# The Proposed New Astoria Combustion Turbine Generator and New York State's Clean Energy Future

Prepared for Sierra Club

September 8, 2021

Figure 1. Illustrative New York City supply curve, 2025

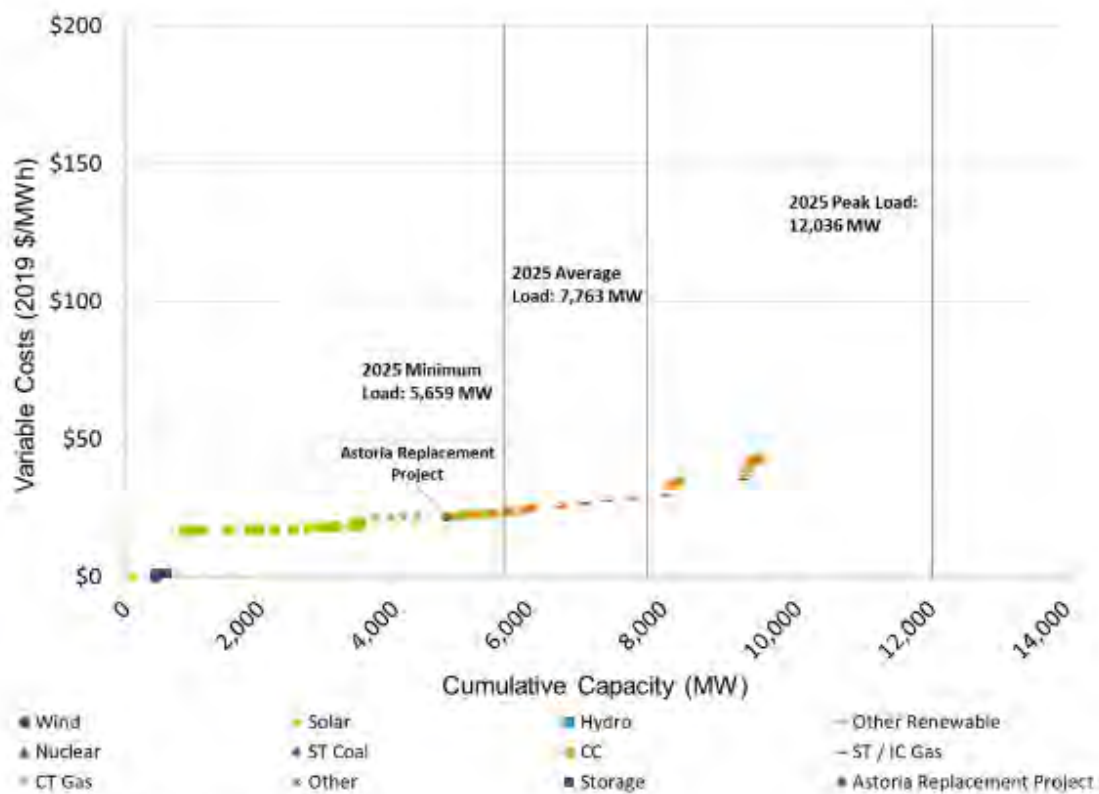
Guidehouse’s method of calculating direct emissions reductions, described above, simply stacks New York City generators in the order of their variable operating costs and assumes that the least-cost generators will always dispatch first. The Astoria CTG is thus assumed to displace the most-costly, least-efficient, and highest-emitting peaking units. This methodology does not consider that transmission

within New York City can be constrained, and thus the least-cost generators are not always able to displace the highest-emitting peaking units in every hour during which they operate. Modeling the transmission constraints within Zone J would likely lead to a lowering of the direct emissions reductions estimated by Guidehouse in its analysis. The Guidehouse report also does not specify which generators are assumed to be displaced, or where those generators are located. There are nine sub-zonal load pockets in Zone J, and thus not all generators can be expected to serve all loads. This lack of data makes it impossible to discern whether the higher cost generators that were assumed to be displaced would actually be displaced by generation from the Astoria CTG.

Figure 3. Guidehouse forecast of NYISO capacity additions and retirements, February 2021

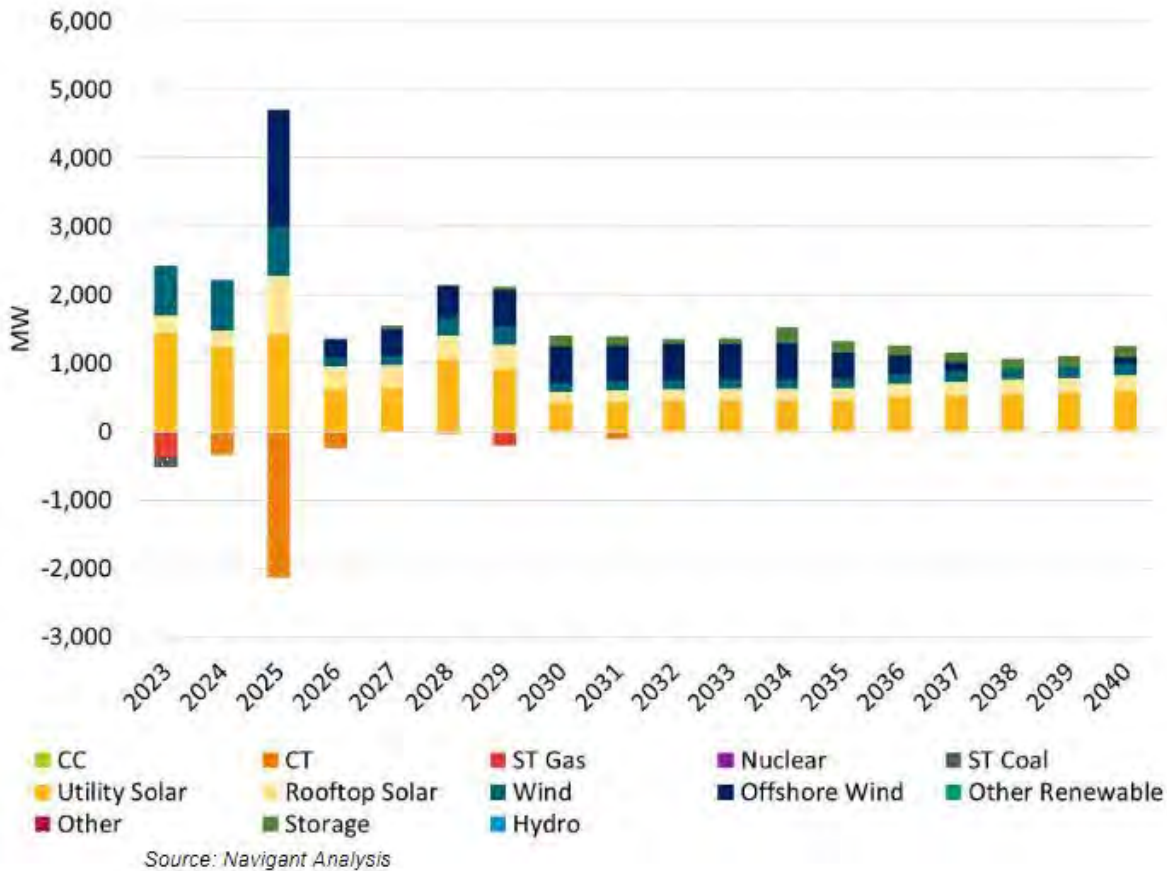
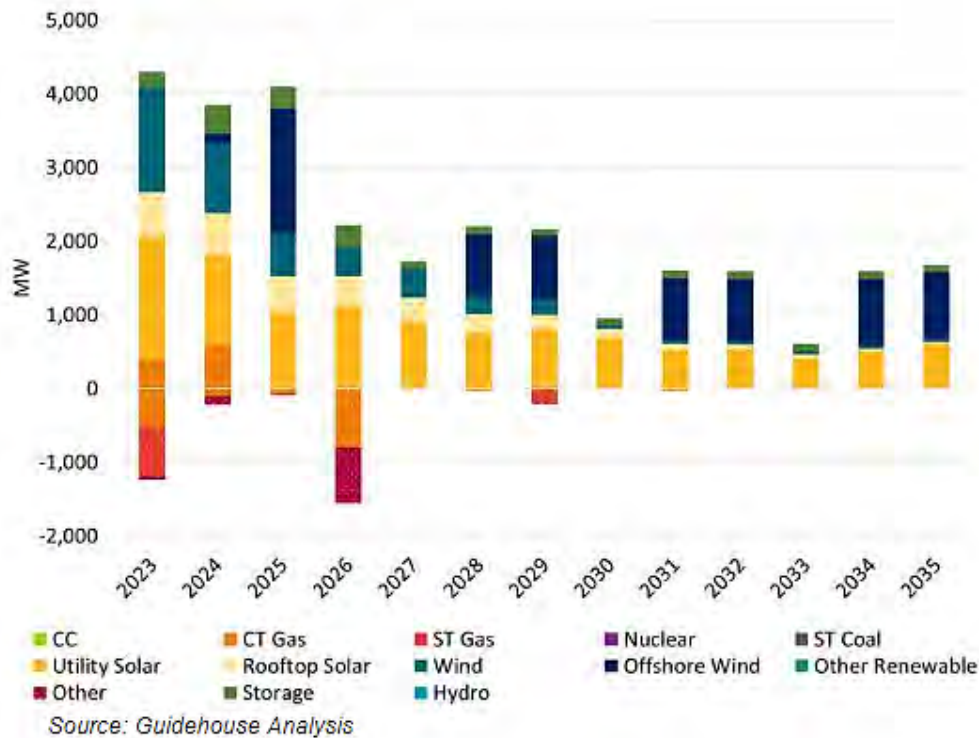
From April 2020 to February 2021, a period of less than a year, the forecasted capacity additions in 2023 and 2024 practically doubled, with increases to the volumes of utility-scale solar, rooftop solar, and onshore wind. Battery storage resources, which did not show up until 2030 in the April 2020 analysis, occur in all years in the February 2021 analysis. Guidehouse did not provide an explanation for these changes, however, they lead to a sizable drop in the amount of direct emissions reductions expected from the Astoria CTG in the Guidehouse analysis, particularly after 2025. A comparison of the direct emissions reductions estimates from the two reports is shown in Figure 4 on both an annual and cumulative basis.

Despite the increase in projected capacity additions in the February 2021 supplement, both Guidehouse forecasts appear to have overlooked the potential for Tier 4 renewable resources from upstate New York and/or Canada to contribute to new capacity additions in New York City. In response to its request for proposal (RFP) for Tier 4 resources, the New York State Energy Research & Development Authority (NYSERDA) received 35 proposals from seven bidders for a total of more than 35 million MWh of renewable energy per year and nearly 7,500 MW of new renewable transmission capacity.<sup>6</sup> If even one or two of those proposals were selected, they would substantially change the assumed generation mix and resulting GHG emissions. The addition of these Tier 4 resources would decrease Guidehouse’s projected direct emissions reductions from the new Astoria CTG. At a minimum, Guidehouse should have acknowledged this uncertainty and conducted sensitivity analyses around the potential impact of Tier 4 resource additions.
